8-02014 CLARKSBURG TOWN CENTER

Re: Clarksburg Town Center – Site Plan 8-02014 Phase 2

SUBJECT: Site Plan Review #8-8-02014 - Clarksburg Town Center Phase II

SUBJECT: Clarksburg Town Center, Phase II – Site Plan No. 8-02014

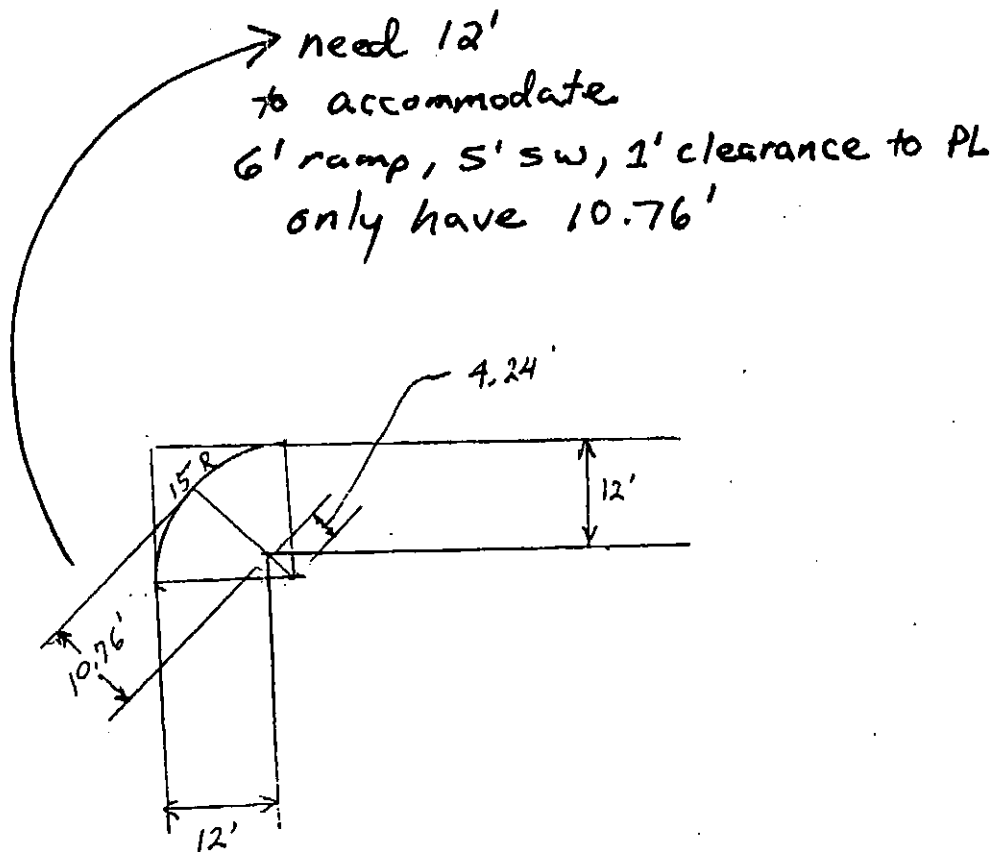
- Block N – the street block adjacent to Lots 39-42 must be private since its only egress is via an alley on the north. We recommend that a waiver be granted to allow single - family houses on a private street. The loop road around the central square should be shown as one-way counterclockwise. A horizontal curvature waiver is needed for the curve on the southwest corner of the square.

- Block M – the loop road around the square will need a horizontal curvature waiver. However, the radius on the curve on the east corner still needs to be increased. The loop road around the square should be shown to operate one-way counterclockwise.

- Grapevine Ridge Road will operate one-way northbound; this should be shown on the plan. The chokers at either end of Grapevine Ridge Road south of Clarksburg Square Road should be eliminated.

- Curb ramps at intersections must meet MCDPWT and ADA dimensions; this may require some additional right-of-way (truncation) at some intersections. The attached drawing shows that where truncations are not provided on tertiary streets, the required space to install the six foot long ramp, a five foot level sidewalk area and one foot of clearance to the property line is not available.
